WORKMAN CLARK (1928) LIMITED

No. 505.

We are in receipt of your letter of the 5th inst. returning one copy of our plan of the rudder proposed for this vessel, and note your amendments.

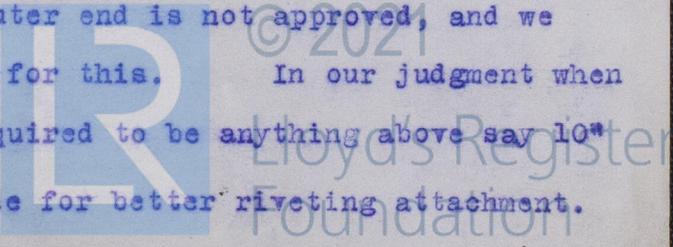
Before proceeding with our working plan we wish to discuss the subject of rudder arms. We are not aware of any indication of your requirements in this regard except the dimensions given in table 43, where the breadth of the arm corresponds with the diameter of the rudder head. In submitting our plan for this vessel we made the width at the inner end less than the table, because we were fitting one arm more than required by rule. We note this is approved, but that our proposal to taper the arms to 8" at the outer end is not approved, and we cannot understand the reason for this. In our judgment when the arms at the stock are required to be anything above say 10" these if tapered would provide for better riveting attachment.

/ We enclose duplicate print showing full size the riveting in the ends of the arms as proposed by us with the alternative as modified by you, and we shall be glad if you will further consider this matter.

P.S. Alternatively you may consider carrying the arms out for their full width to say half the length of the rudder, and then tapering them to the outboard end.
